SUBJECT: SURRY UNITS 1 AND 2 - ISSUANCE OF AMENDMENTS RE: CONTROL ROD  
ASSEMBLIES AND SURRY IMPROVED FUEL (TAC NOS. 63166, 63167,  
65432, 65433, 65561 AND 65562)

Amendment No. 116  
License No. DPR-32

SAFETY EVALUATION BY THE OFFICE OF NUCLEAR REACTOR REGULATION  
RELATED TO AMENDMENT NO. 116 TO FACILITY OPERATING LICENSE NO. DPR-32  
AND AMENDMENT NO. 116 TO FACILITY OPERATING LICENSE NO. DPR-37

VIRGINIA ELECTRIC AND POWER COMPANY  
SURRY POWER STATION, UNIT NOS. 1 AND 2

FIGURE 3.12-1A CONTROL BANK INSERTION LIMITS FOR 3-LOOP  
NORMAL OPERATION-UNIT 1

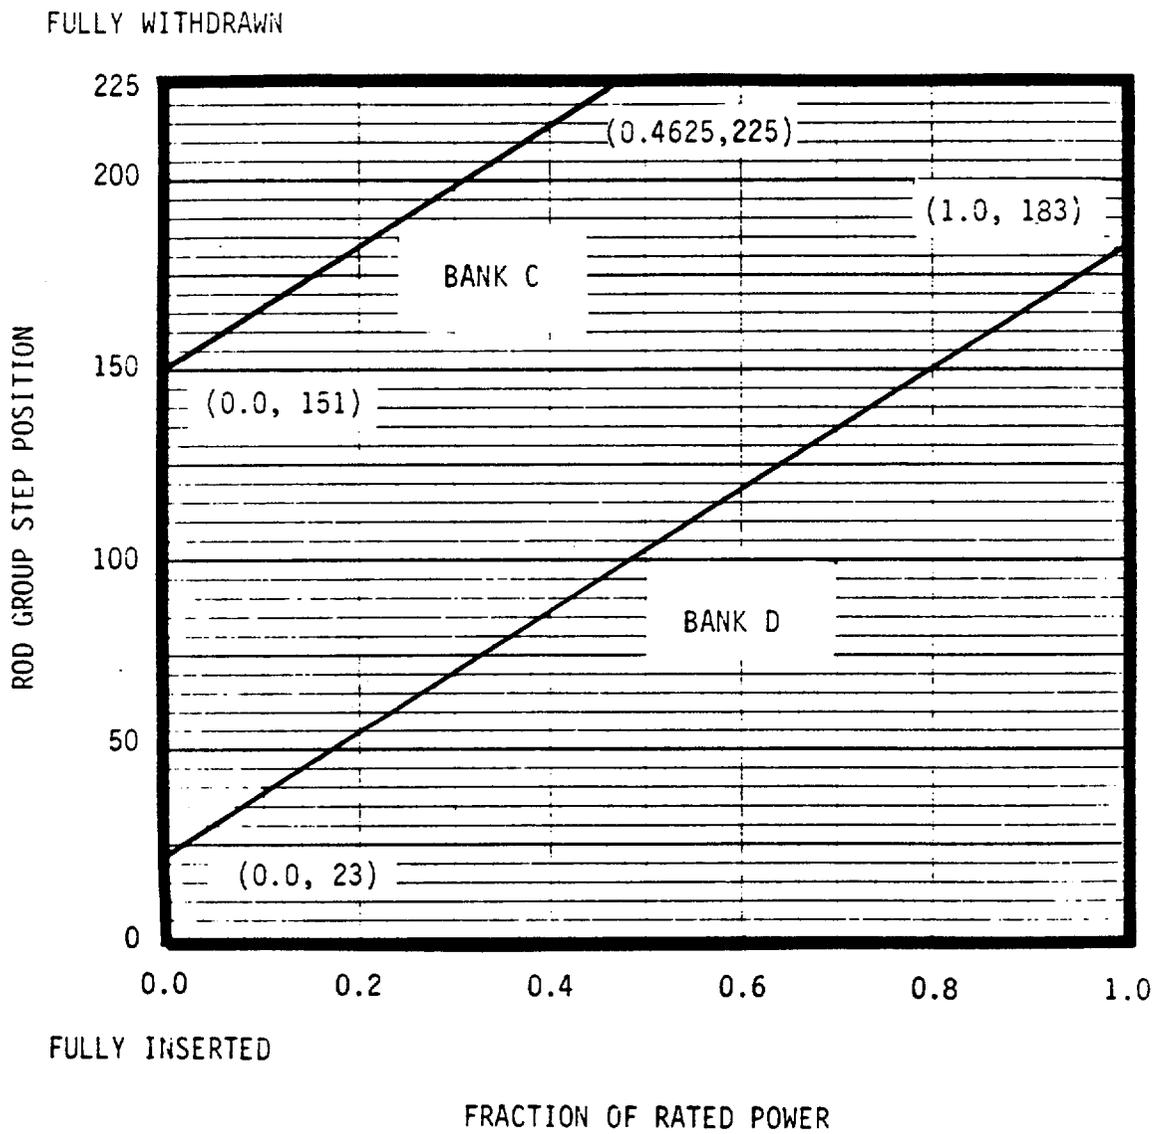
By letter dated April 1, 1987, the licensee requested to revise Figures 3.12-1A and 3.12-1B of the Surry TS, which govern the control rod insertion limit. The licensee proposed redefining the fully withdrawn position of all rod cluster control assembly (RCCA) banks to 225 steps, instead of the current 228 steps. The change will allow greater operational flexibility with regard to control rod bank positioning as a means of minimizing localized RCCA wear.

By letter dated April 1, 1987, the licensee proposed to redefine the fully withdrawn position of all RCCA banks to 225 steps, which would eliminate localized RCCA wear at the top of the control rods. The current fully withdrawn position is 228 steps. At 225 steps withdrawn, the RCCAs are only 0.31 inches into the active fuel region (228 steps withdrawn is above the active fuel region). Since the top region of the core has such low worth, the effect of the proposed change was expected to be minimal. To confirm this, neutron calculations were performed by the licensee.

The shutdown margin calculations showed a 0.003%  $\Delta\rho$  decrease at beginning-of-life (BOL) and a 0.006%  $\Delta\rho$  decrease at end-of-life (EOL) (recent cycles have excess shutdown margin of approximately 1.75%  $\Delta\rho$  at BOL and 1.6%  $\Delta\rho$  at EOL). The changes in the other parameters which would be affected are similarly minimal with respect to available margins.

Because the proposed change will result in slight insertion of the RCCAs into the active fuel region, the staff expects essentially negligible effects due to the proposed change. Therefore, the staff concludes that the proposed change is acceptable.
